World Forum for Harmonization of Vehicle Regulations

173rd session

Proposal for 08 series of amendments to UN Regulation No. 14 (Safety-belt anchorages)

Submitted by the Working Party on Passive Safety*

Model A

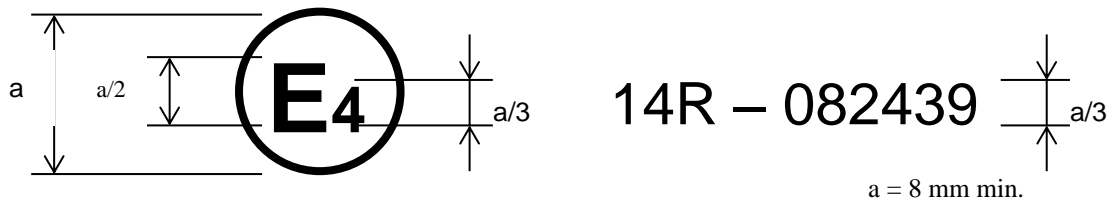
Annex 2, amend to read:

The above approval mark affixed to a vehicle shows that the vehicle type concerned has, with regard to safety-belt anchorages, been approved in the Netherlands (E 4), pursuant to UN Regulation No. 14, under the number 082439. The first two digits of the approval number indicate that UN Regulation No. 14 already included the 08 series of amendments when the approval was given.

Model B

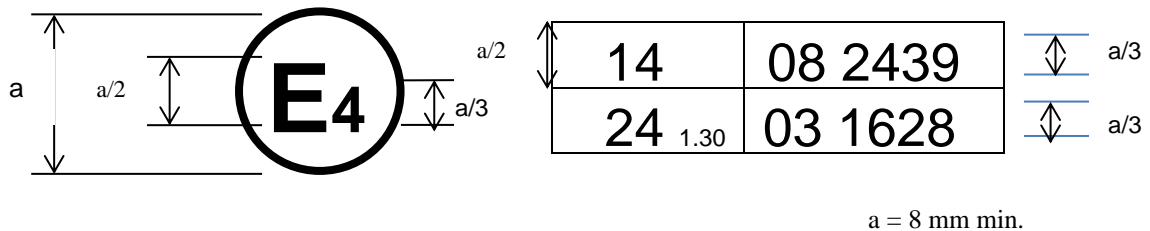
The above approval mark affixed to a vehicle shows that the vehicle type concerned has been approved in the Netherlands (E 4) pursuant to UN Regulations Nos. 14 and 24*. (In the case of the latter Regulation the corrected absorption co-efficient is 1.30 m⁻¹). The approval numbers indicate that on the dates on which these approvals were granted, UN Regulation No. 14 included the 08 series of amendments and UN Regulation No. 24 was in its 03 series of amendments.
